MARKED-UP TECHNICAL SPECIFICATION PAGES

PRESSURE-TEMPERATURE LIMITS

(JPTS-99-003)

JAMES A. FITZPATRICK NUCLEAR POWER PLANT

Figure 3.6-1 Part 1 Reactor Vessel Pressure-Temperature Limits Through 24 EFY

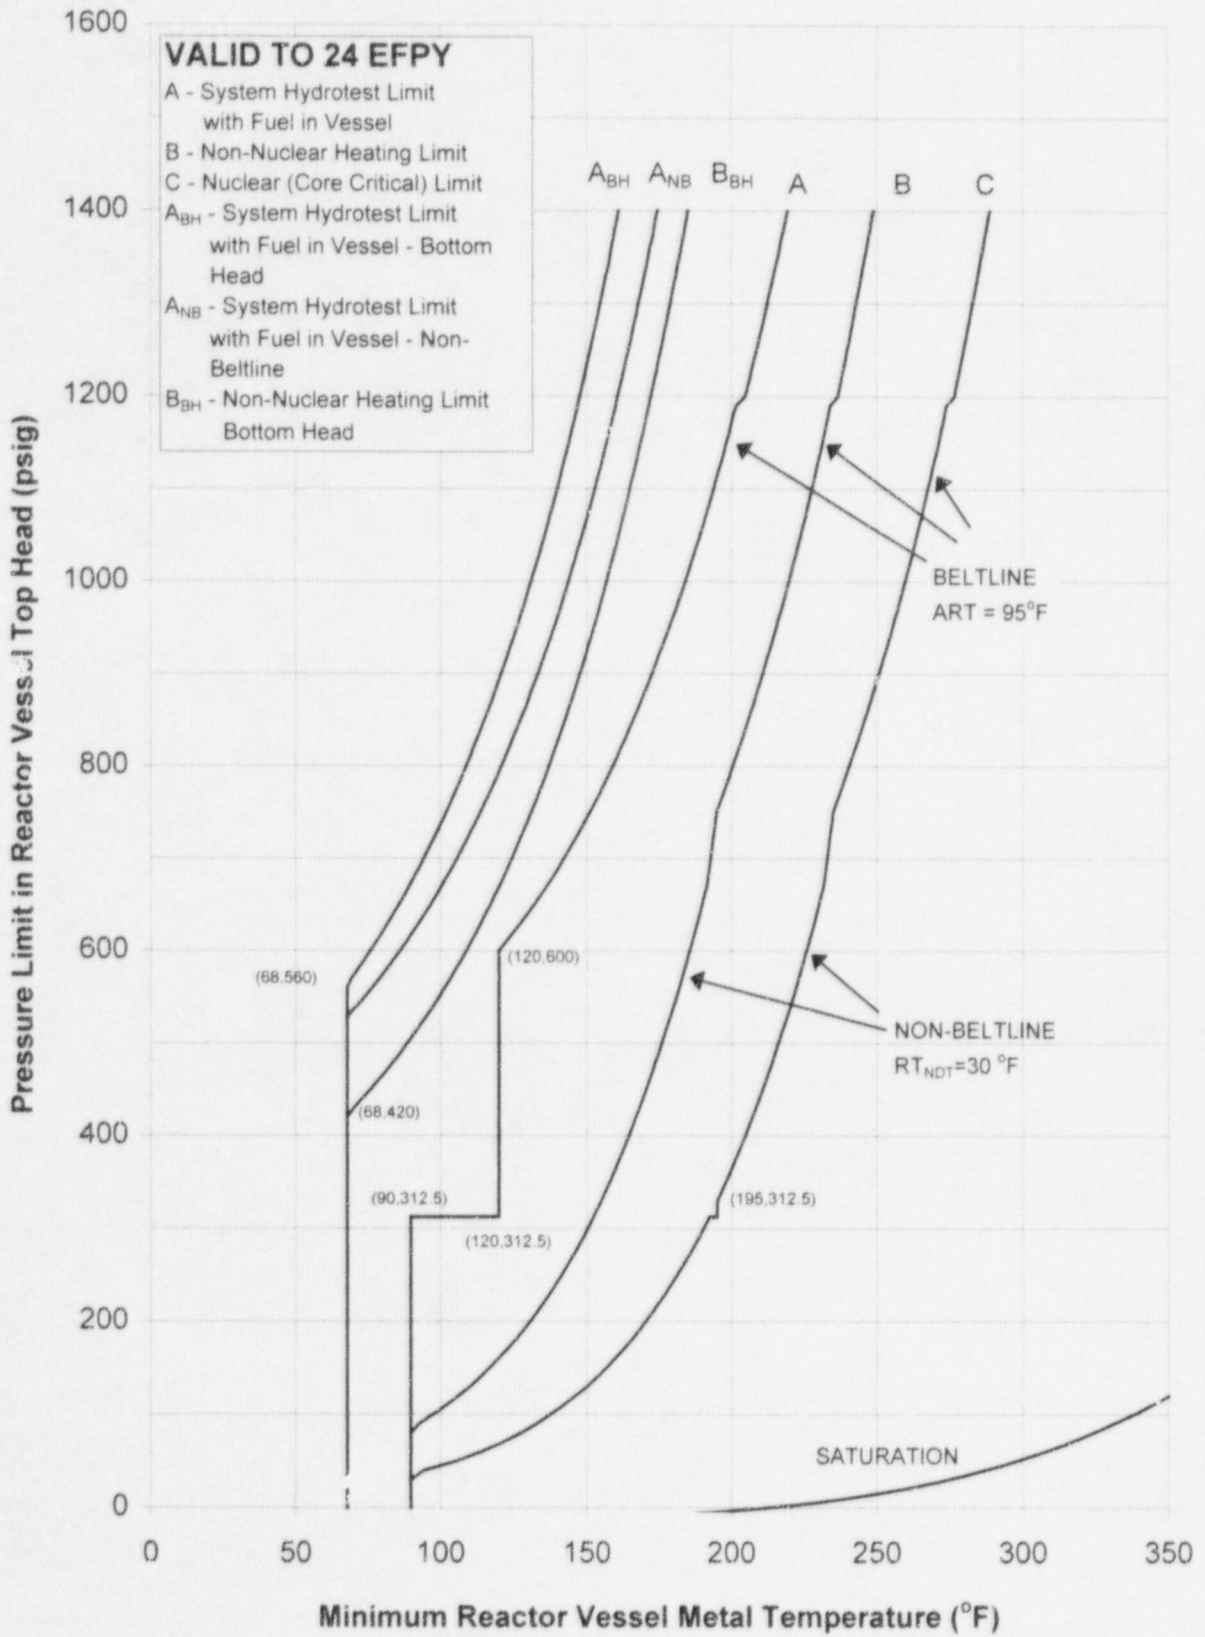
Figure 3.6-1 is comprised of two parts: Part 1 and Part 2. Part 1 establishes the pressure-temperature limits for the bottom head, flange, upper vessel and beltline regions for plant operations through 24 Effective Full Power Years (EFPY). Part 2 establishes the pressure-temperature limits for plant operations through 32 EFPY. The curves contained in Figure 3.6-1 are developed from the General Electric Report GE-NE-B1100732-01, Revision 1 (February 1998), including Errata and Addenda dated June 1999.

**Figure 3.6-1 Part 1 Reactor Vessel Pressure-Temperature
Limits Through 12 EFPY**

Figure 3.6-1 Part 2 Reactor Vessel Pressure-Temperature Limits Through 32 EFPY

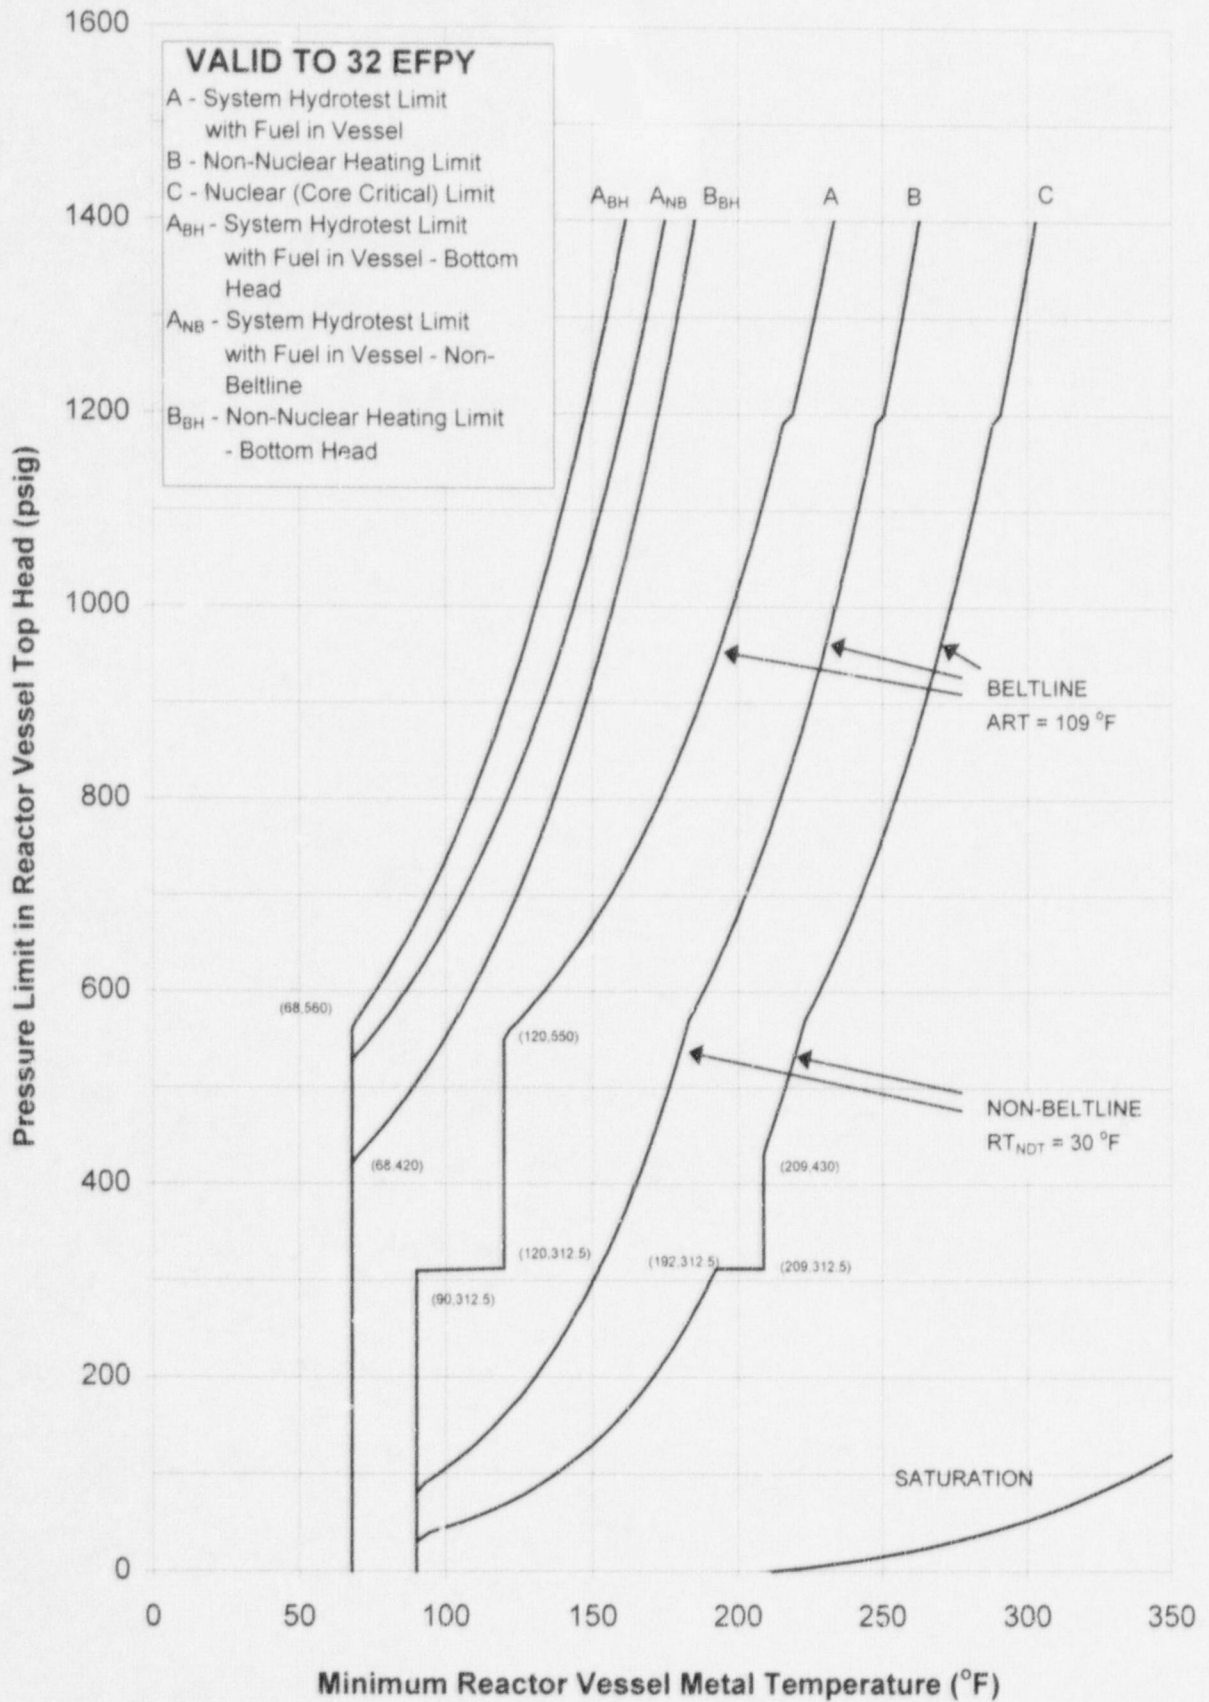
~~Figure 3.6-1 Part 2 Reactor Vessel Pressure-Temperature
Limits Through 14 EFPY~~
